October 28th, 1958.
Re: Randall-Rebecca Street
Bridge, Town of Oakville.

We have reviewed the report and recommendations of the Consultants concerning this bridge, as requested by your memorandum of October 17th, 1958, and wish to make the following remarks:-

BRIDGE SITE INVESTIGATION
REBECCA STREET BRIDGE
OAKVILLE, ONTARIO

FIG 1

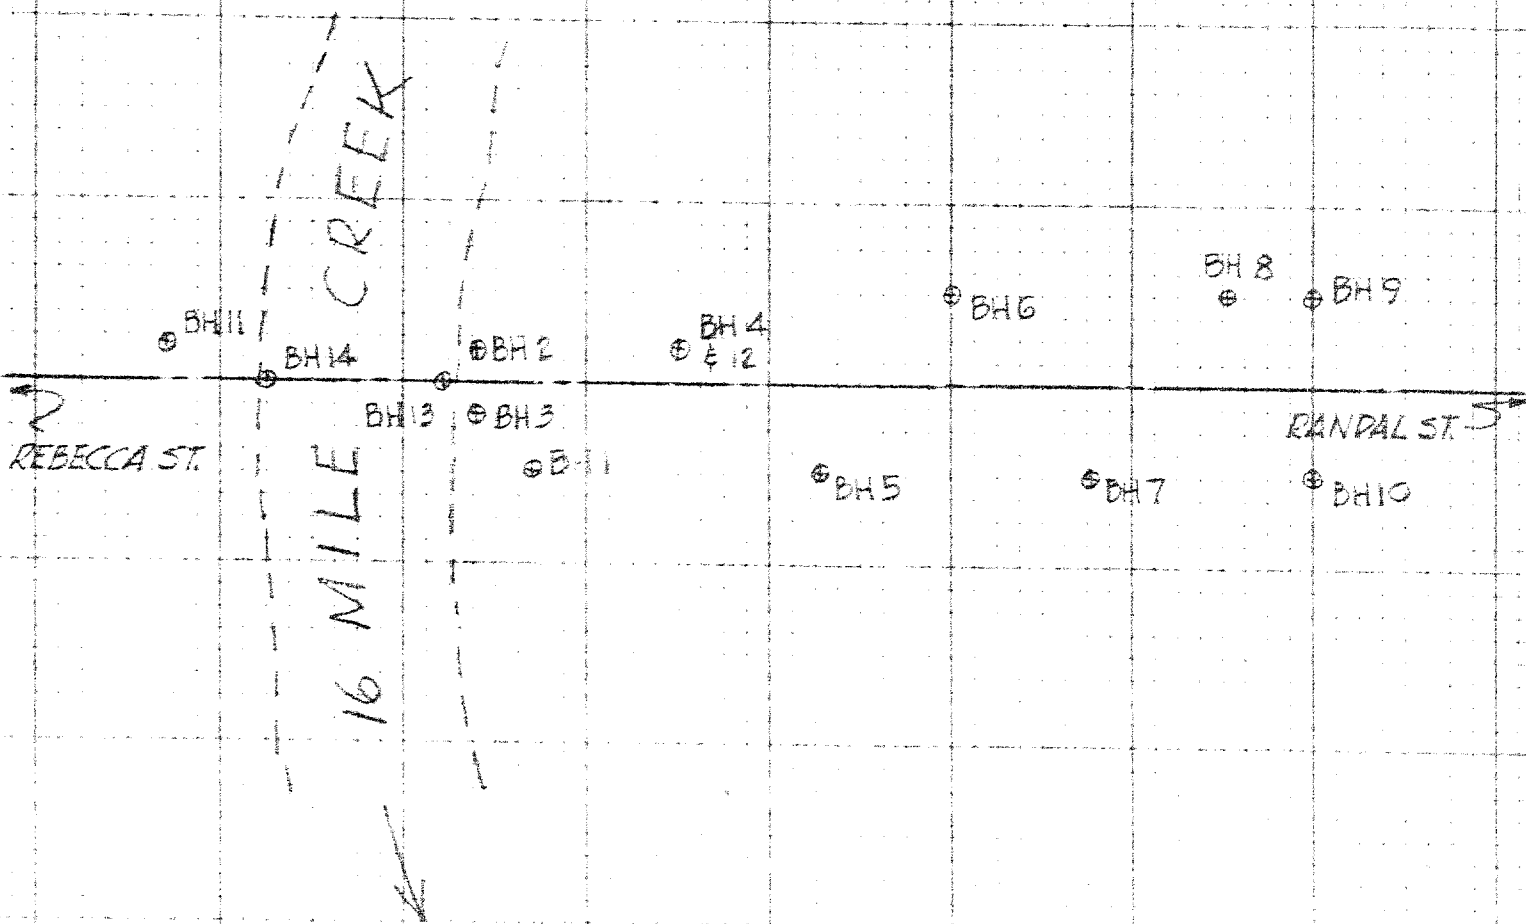
6. In our opinion the presentation of the boring results plan location boreholes and subsurface section across the valley in the soils report could stand improvement.
